RIVER FOREST DEVELOPMENT REVIEW BOARD MEETING AGENDA

Subj: Planned Development - Keystone Park Improvements (River Forest Park District)

SUBJECT: River Forest Park District – 7920 Lake Street

Keystone Park – Tennis & Batting Cage Area Improvements

Sheets ED-1 through E-4

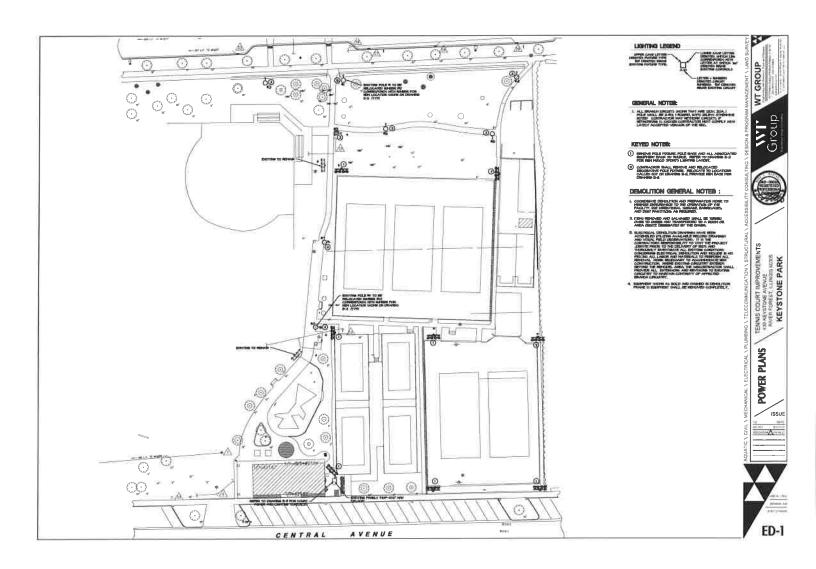
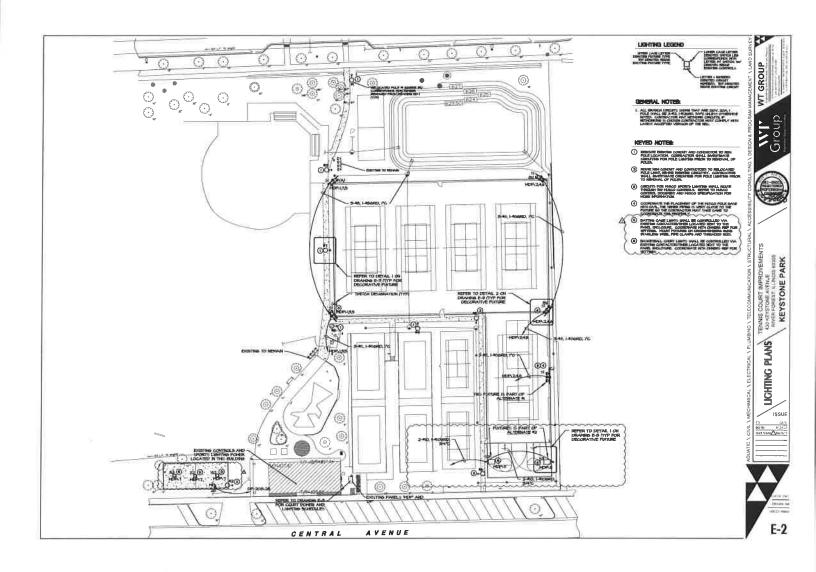
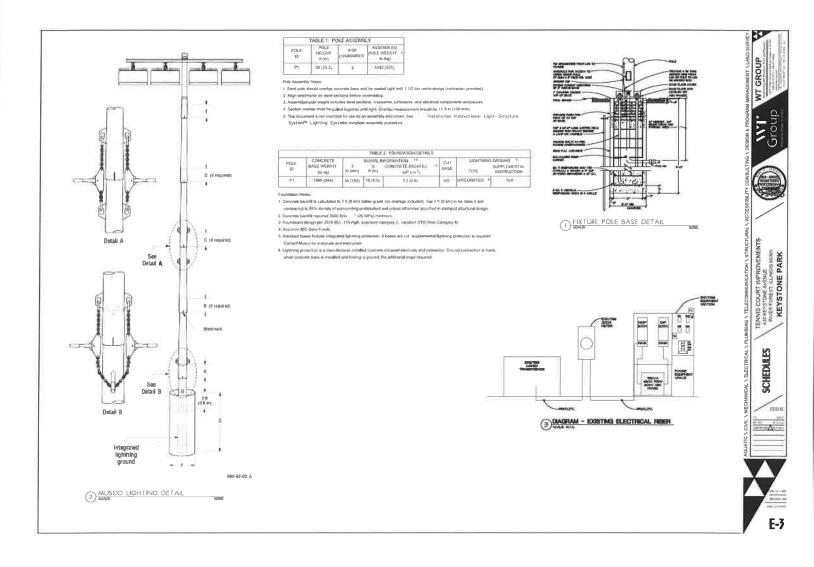
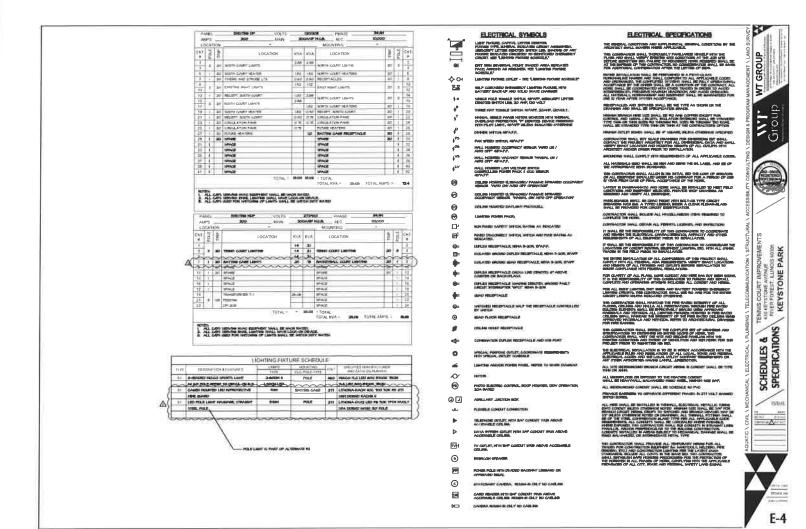
- Additional lighting was added to the batting cages in the southwest corner of the project.
- 2. Alternate # 2 was added for the addition of lighting for the basketball courts.
- 3. Please see the attached bid form for updates to the Base Bid language as well as the addition of Alternate # 2 to the project.

- 6. The electrical plans have been updated to include additional lighting for the batting cages in the southwest corner of the project.
- 7. Alternate # 2 has been added to the project. Alternate # 2 is an alternate being provided for the addition of two (2) site area lights to light the proposed basketball court.
